ADDENDUM #2

CR 565/Villa City Road from North of SR 50 to South of US 27
Project No. 2024-01, Bid No. 25-517
FPN #447609-1-58-01

RESIDENTIAL DRIVEWAY

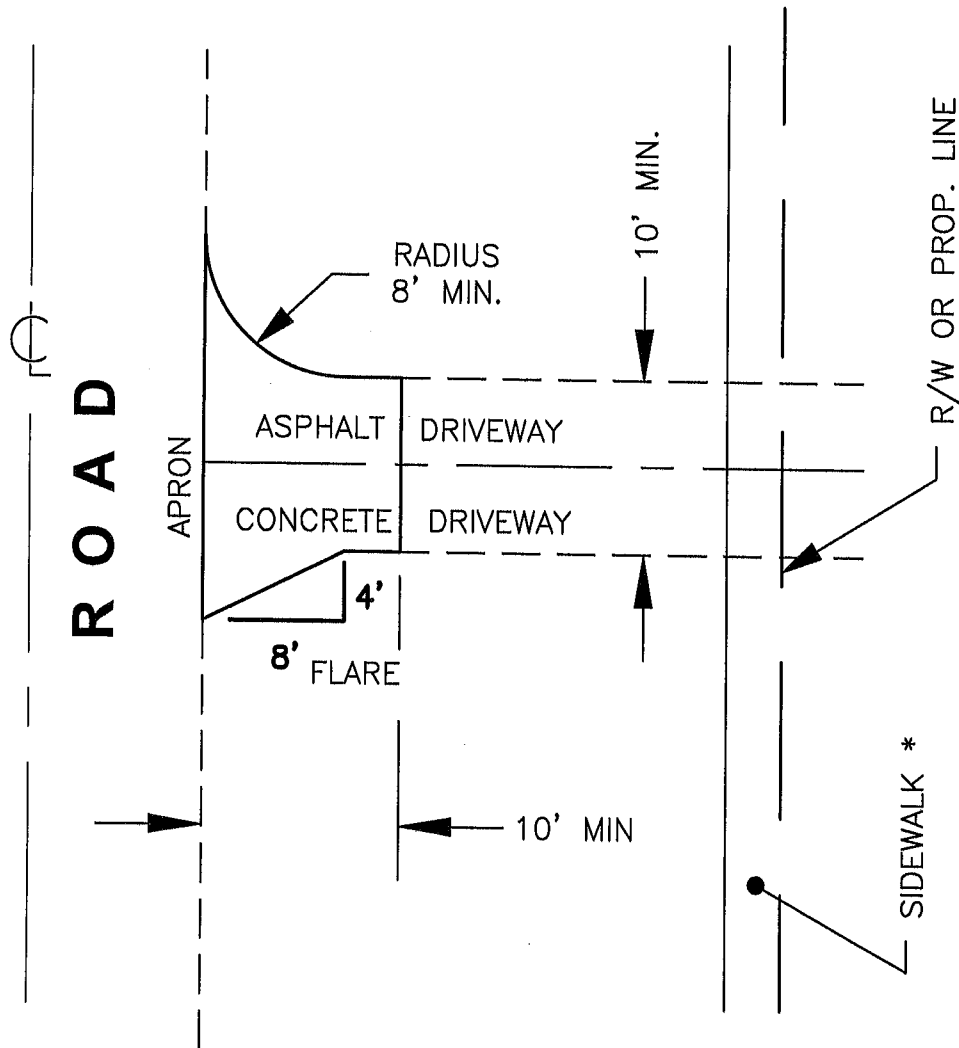
Q1. Can the engineer please provide a detail for the driveways (asphalt and concrete)?

Q5: FDOT Standard Index 330-001 is referenced for new concrete driveway aprons. Standard Index 330-001 applies to asphalt paved driveways. Please explain this reference.

Q6: FDOT Standard Index 300-001 is referenced for new asphalt driveways and turnouts. Standard Index 330-001 requires Optional Base Group 2 or 3. There are no bid items for Optional Base 2 or 3. Please explain.

A1. Please see attached County detail for residential driveways for asphalt and concrete.

A5: Please see attached County detail for residential driveways for asphalt and concrete.

A6: Please see attached County detail for residential driveways for asphalt and concrete. Optional Base Group 2 or 3 are not needed.

1" ASPHALT WITH
6" COMPACTED LIMEROCK BASE
& 12" COMPACTED SUBGRADE

OR

6" 3,000 PSI CONCRETE
REINFORCED WITH 10-10x6"x6" MESH
& 6" COMPACTED SUBGRADE
